BID ADDENDUM No. 5

PROJECT NAME	The Williams 20 South Long Street Williamsville, NY 14221
LABELLA PROJECT No.:	2202196
DATE:	July 2, 2021
FROM:	LaBella Associates, D.P.C. 300 Pearl Street, Suite 130 Buffalo, NY 14202

DRAWING NUMBER:
	A201

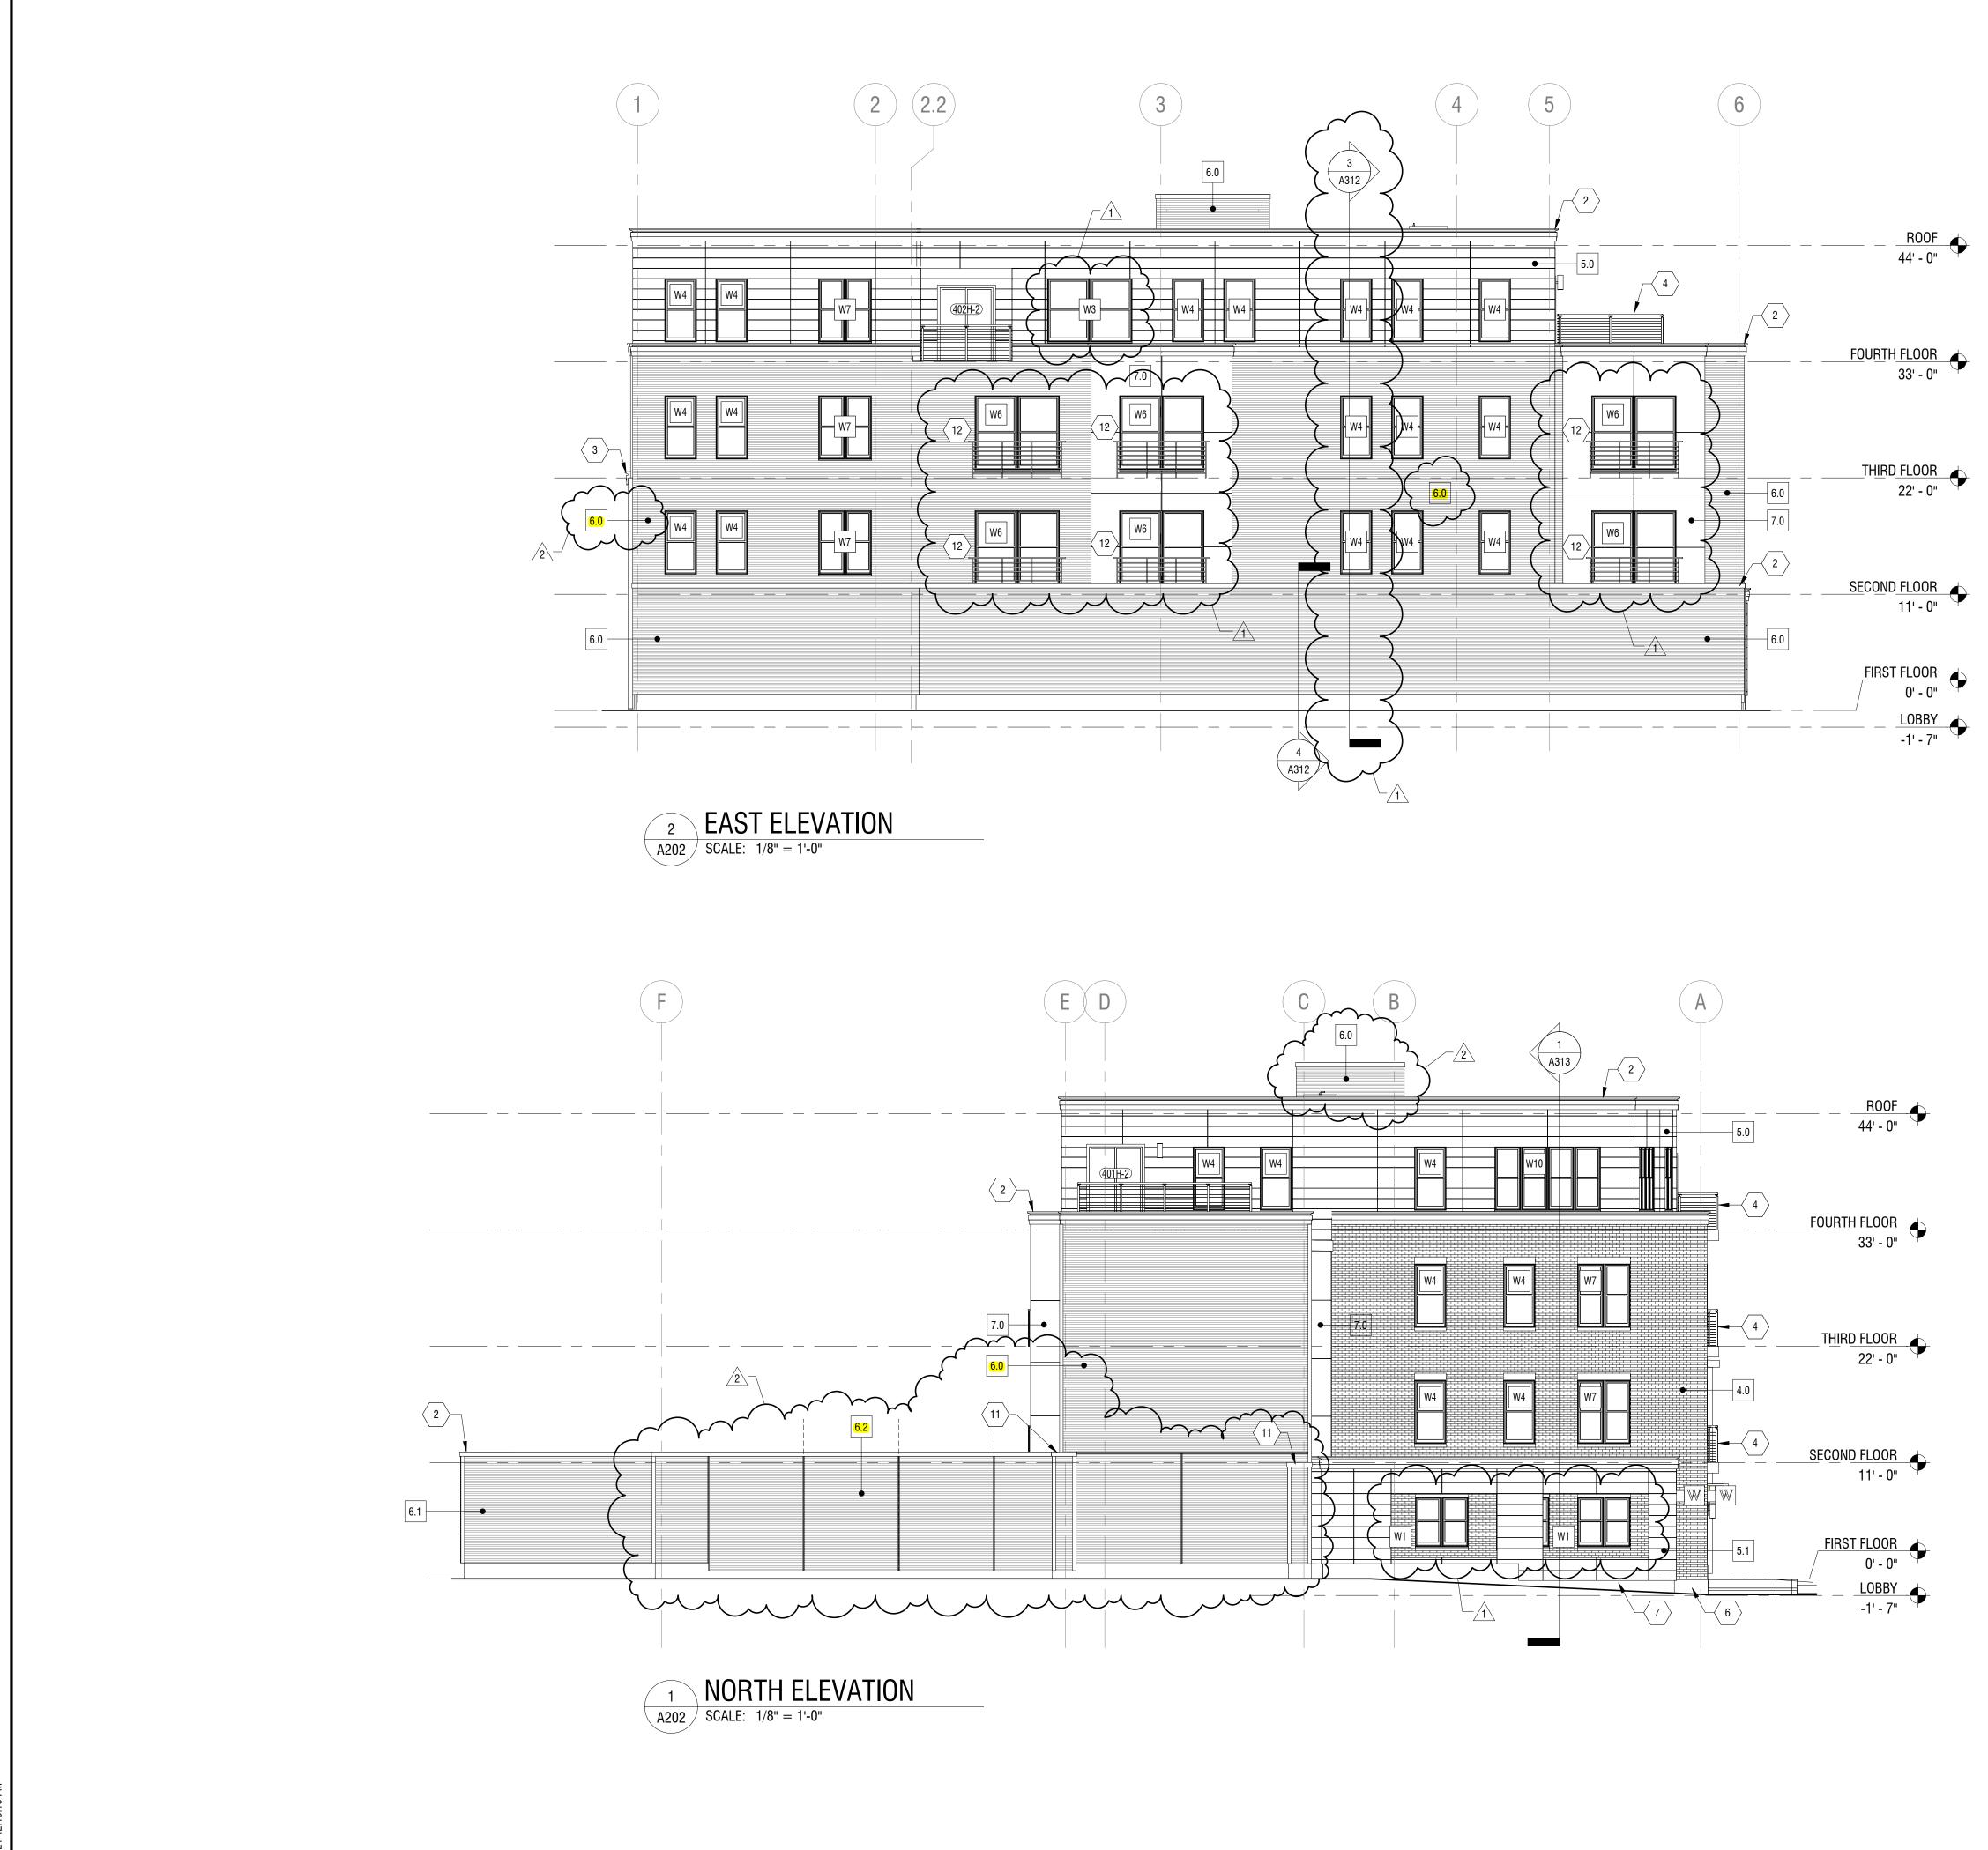
- See attached construction sketch SK-A08 for more information.
- 2. DRAWINGS A201 & A202 | Exterior Elevations
 - A. Revised Wall Assembly designations.

- Incorrect wall assembly designations were called out which did not reflect the desired orientation of exterior siding. Changes have been made on the attached A201 & A202 drawings with revision clouds and tags.

- Orientation of exterior siding on the South Elevation (drawing A201) was incorrect and has been changed to reflect a horizontal installation. A vertical trim piece is now required to change in siding orientation (see note location on South elevation).
